Technical Bulletin

TB#: 0603-1

MODEL NUMBER : VX-1700

Reason for Technical Bulletin: Provide information on updating the VX-1700 for field programming.

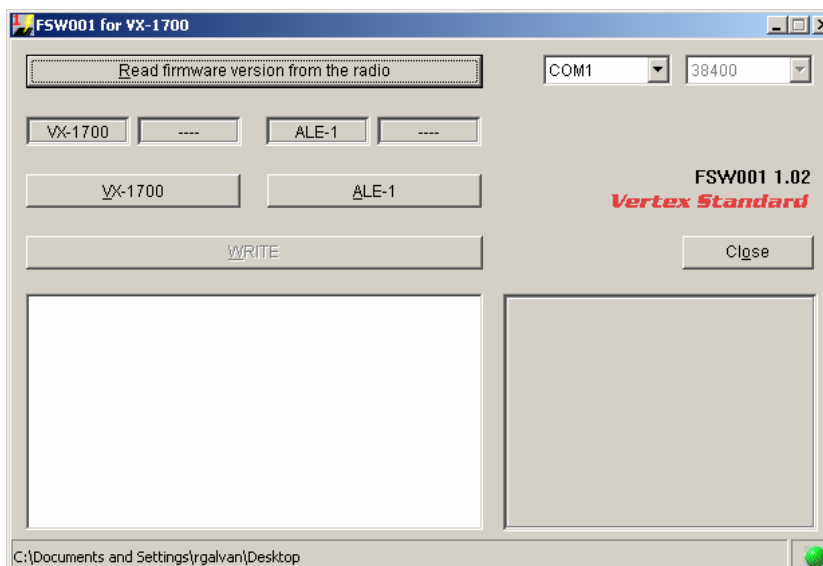
Locate the switch S1001 located next to the cooling fan. Move Switch 3 to the **ON** position.

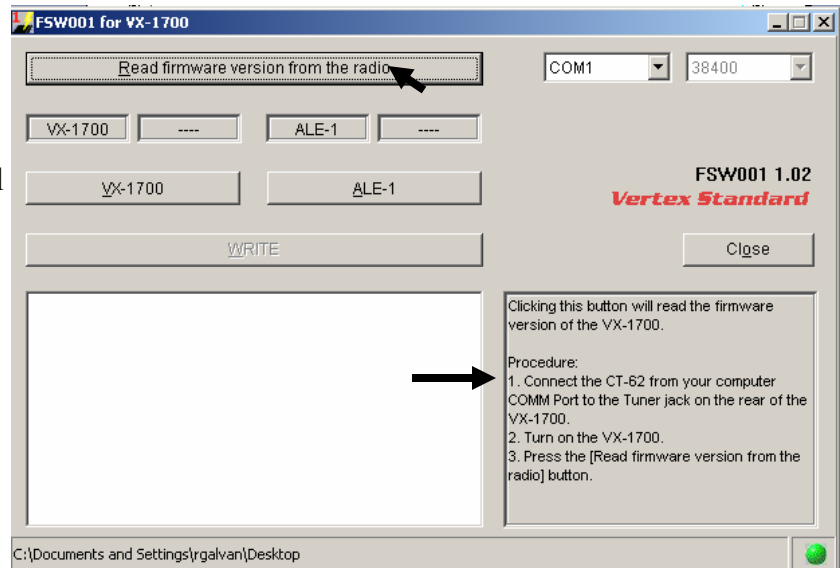
Here you can read the firmware version from the radio by press this button. You will need the normal programming cable (CT-62) for this.

For our purpose, we will send new firmware to the radio. Press the VX-1700 button to load the new firmware (verify version V1013).

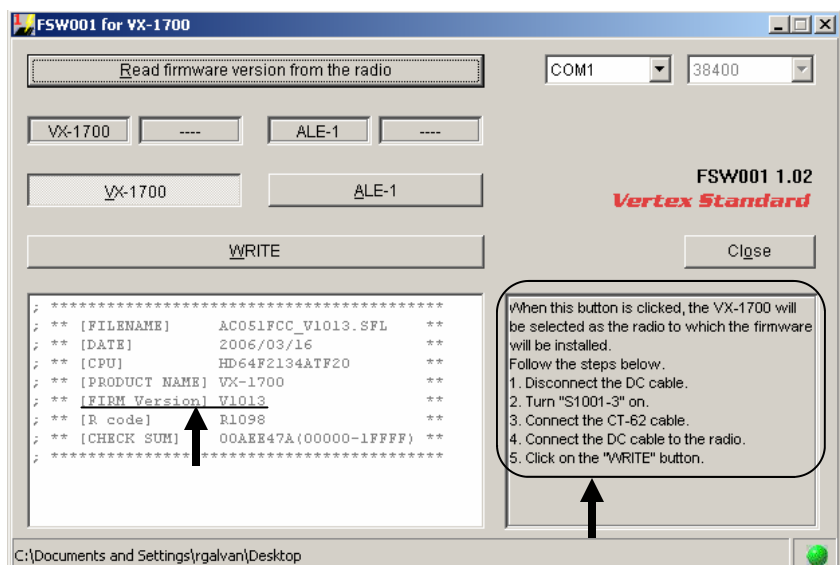
Also, this will show the update procedure in the window to the right.

Once the update process begins, the instructions on the right will be replaced with dual progress bars. When the progress bars are finished, the update process is complete. When finished, an 'OK?' window will appear. Click ok to finish and exit. Make sure to move S1001-3 back to the off position and re-assemble the radio.
